CITY OF NORTH OAKS

Regular Planning Commission Meeting
Thursday, February 29, 2024
7:00 PM, Community Meeting Room, 100 Village Center Drive
MEETING AGENDA

PLANNING REPORT

Mark Englund of Hansen Homes has requested approval of a conditional use permit to allow the construction of a new home at 8 Sherwood Trail to be 44.2 feet in height where 35 feet in is the maximum height permitted in the City Code. The applicant's narrative is attached, as well as building elevations, a survey and a site plan for the proposed structure.

Figure 2- preliminary plans

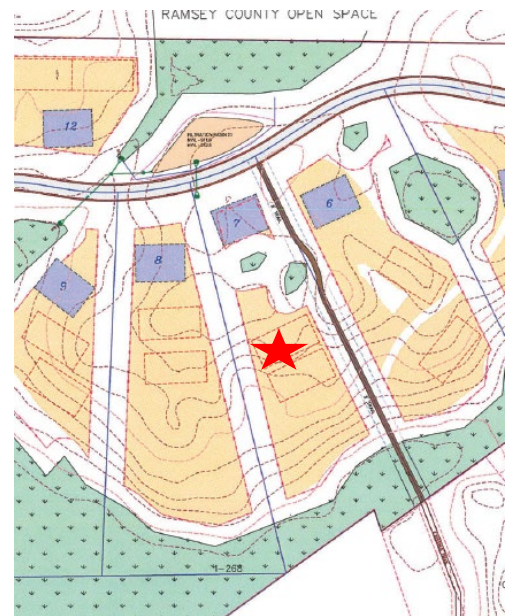
The approved plans for the East Preserve development showed the home site at the front of the lot, which would have eliminated the need for the driveway variance. It is the applicant's responsibility to show that the practical difficulties exist, and that the mandatory criteria for issuance of a variance are met, before the City Council could approve the required variance. Without a variance from the wetland setback requirements, the proposed house cannot be constructed as proposed.

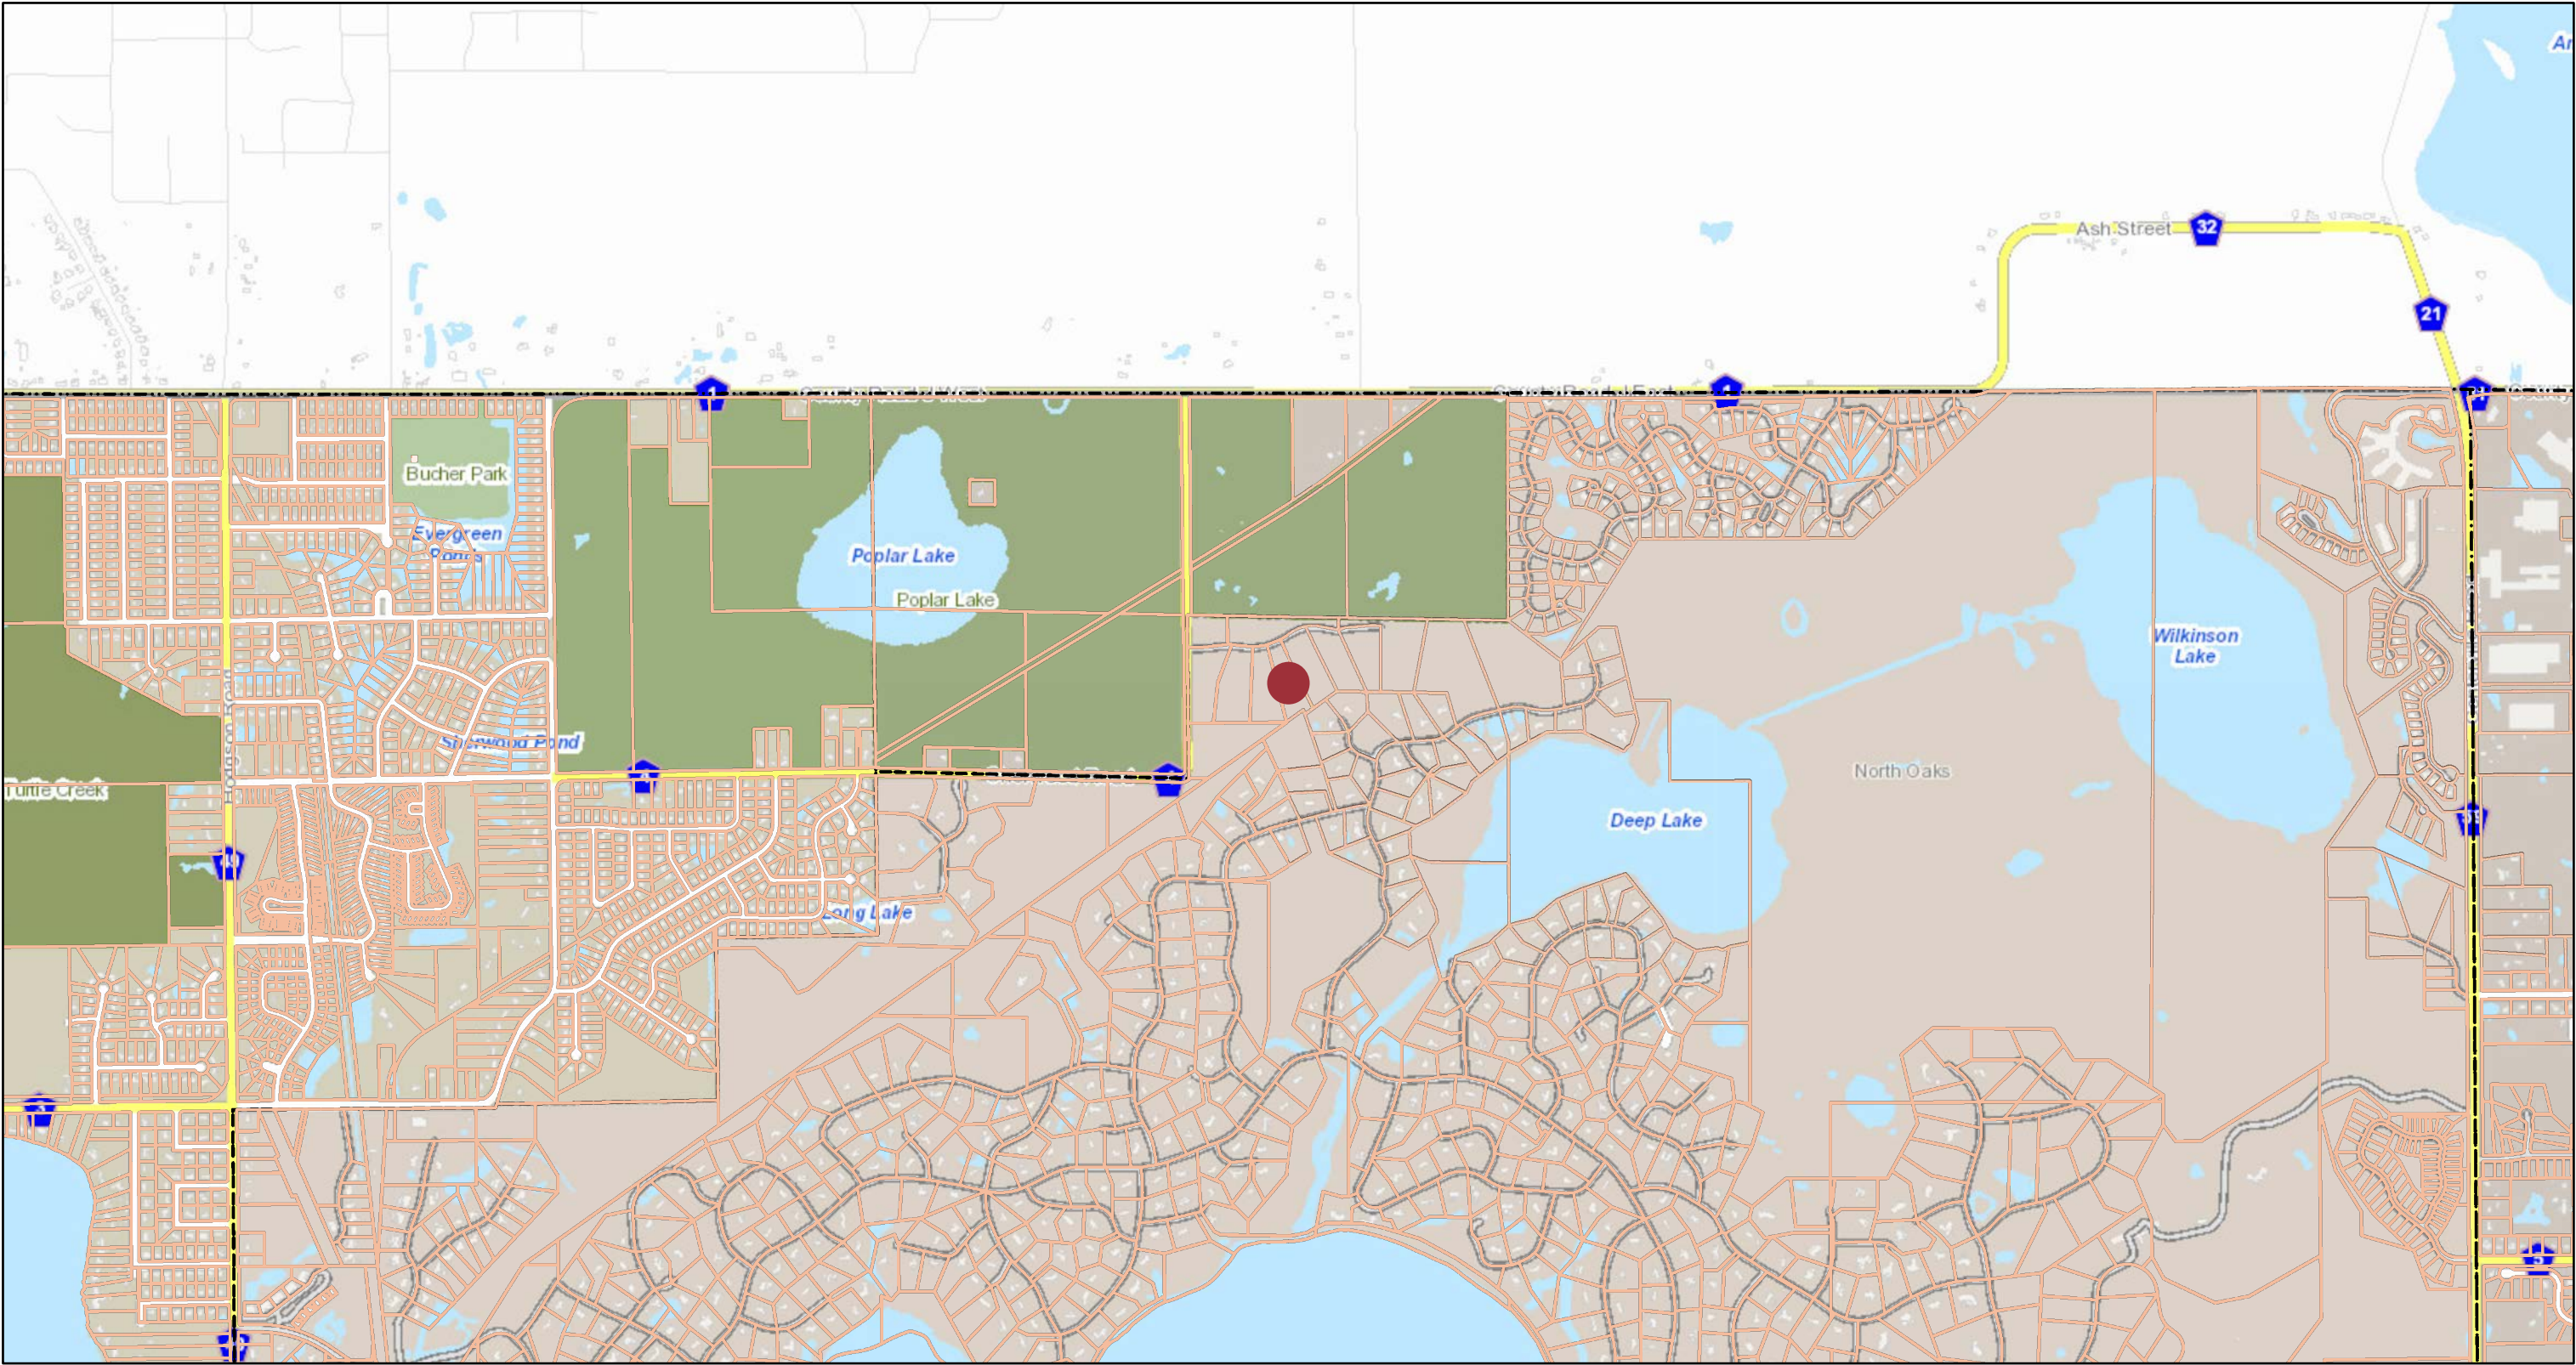
Staff recommends that the Planning Commission continue this request so that the applicant can evaluate options for the lot, revise the plans to show two septic sites and either: 1) apply for a setback variance or revise the plans to comply with the required wetland setbacks.

SHEET TITLE
ELEVATIONS

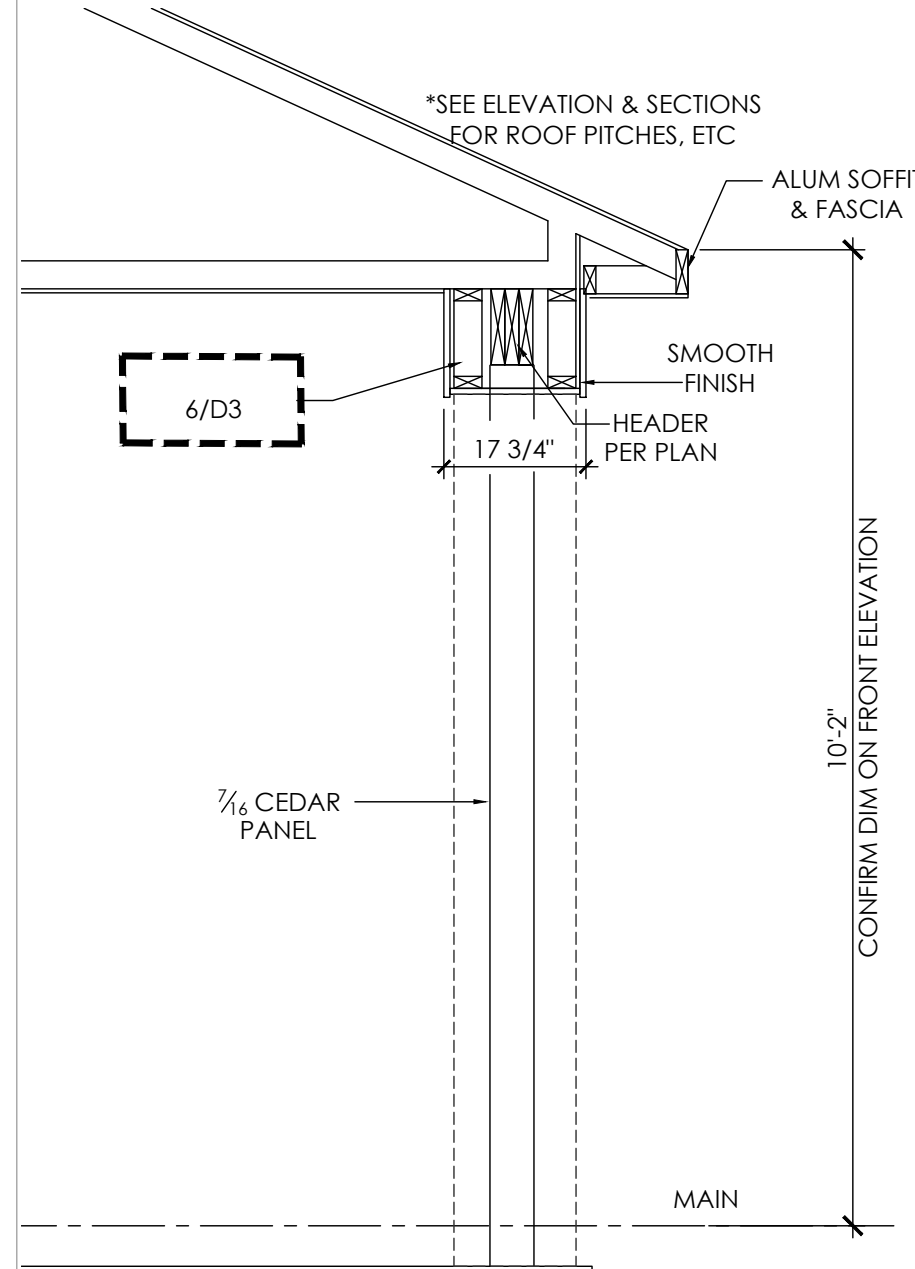
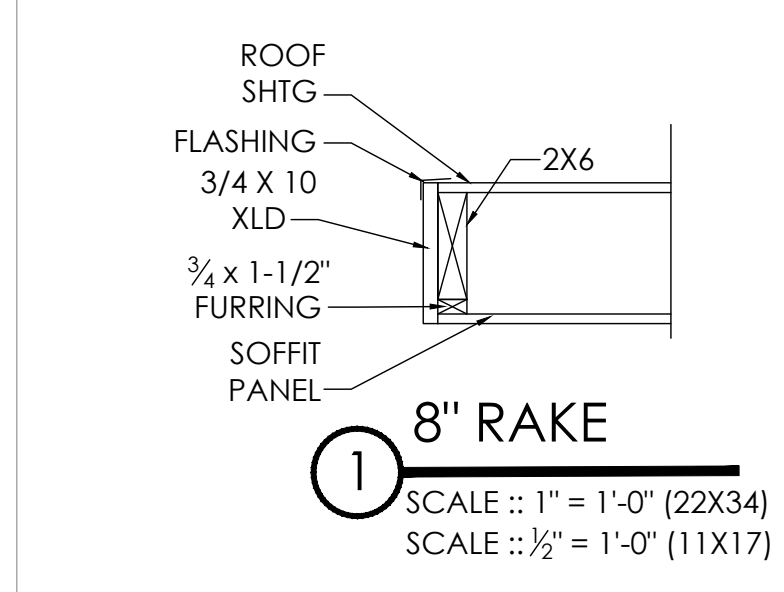
The applicant is requesting a CUP to allow the southern (rear) elevation of the proposed home to exceed 35 feet in height. Elevations provided by the applicant show the proposed home to be 44.2 feet in height along the side and rear facades. The front facade of the home is 34.9 feet in height. Building height is defined as the vertical distance from grade as defined herein to the top ridge of the highest roof surface in Section 151.005 of the Zoning Code.

The proposed front elevation is a maximum of 35 feet tall. The side and rear elevations are 44.2 feet in height. The increased height of the side and rear elevations requires a 50 foot setback from their respective property lines. The rear and west elevations comply with the additional setback standard. The east elevation is situated 42.2 feet from the east property line and must be setback an additional 8 feet. Plans shall be revised to comply with the required 50 foot setback from the side and rear elevations. There is space within the site to shift the building to the west in order to accommodate the additional setback.

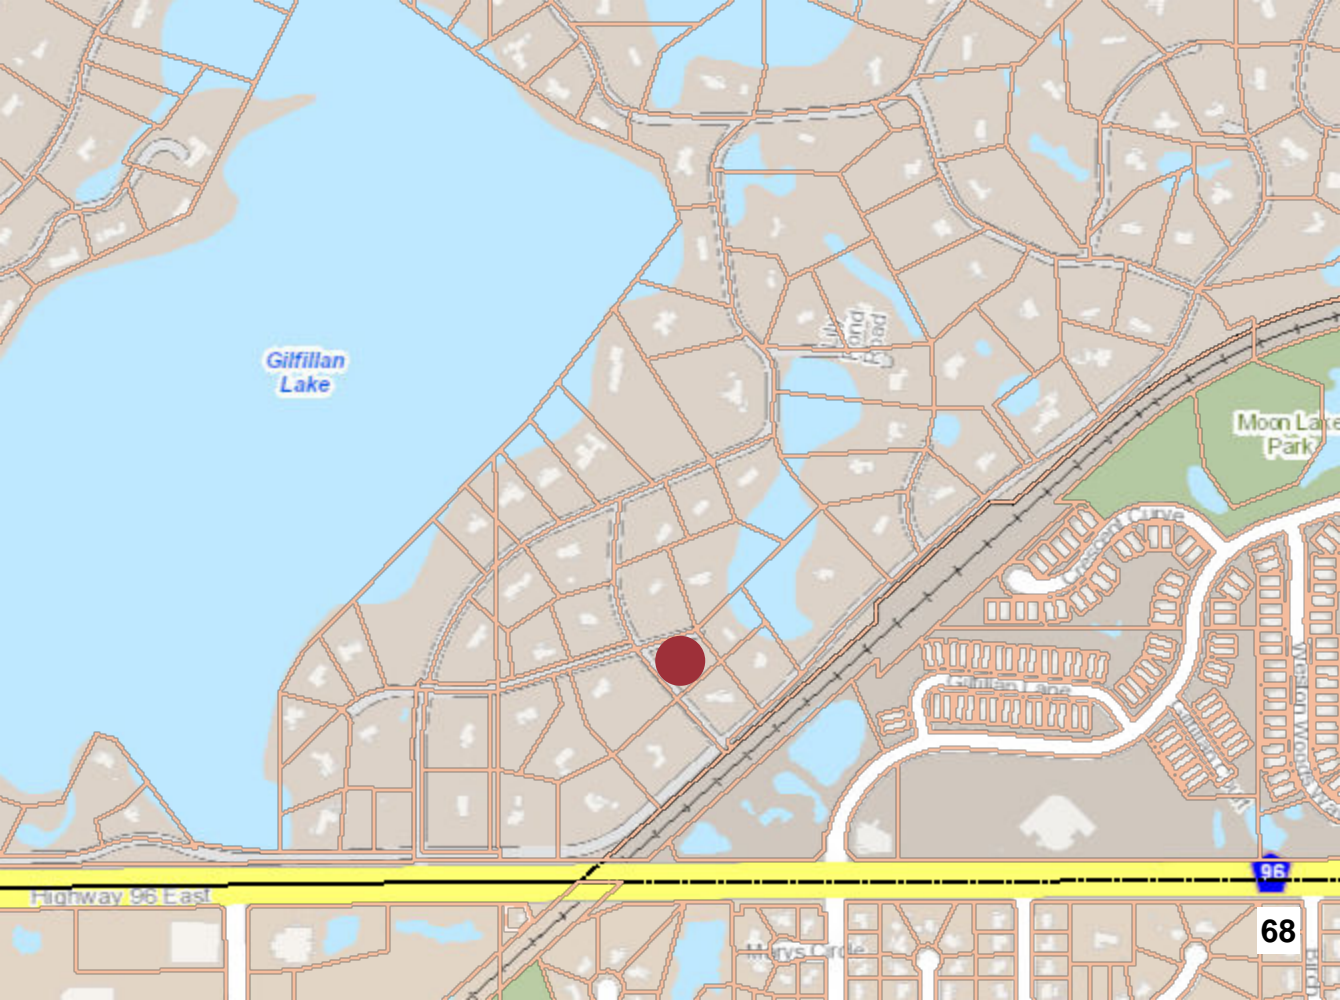
Based on the preceding review, Staff finds that the variance standards are met and that the new system will result in improvement to the local ground and surface waters by eliminating a non-compliant cesspool.
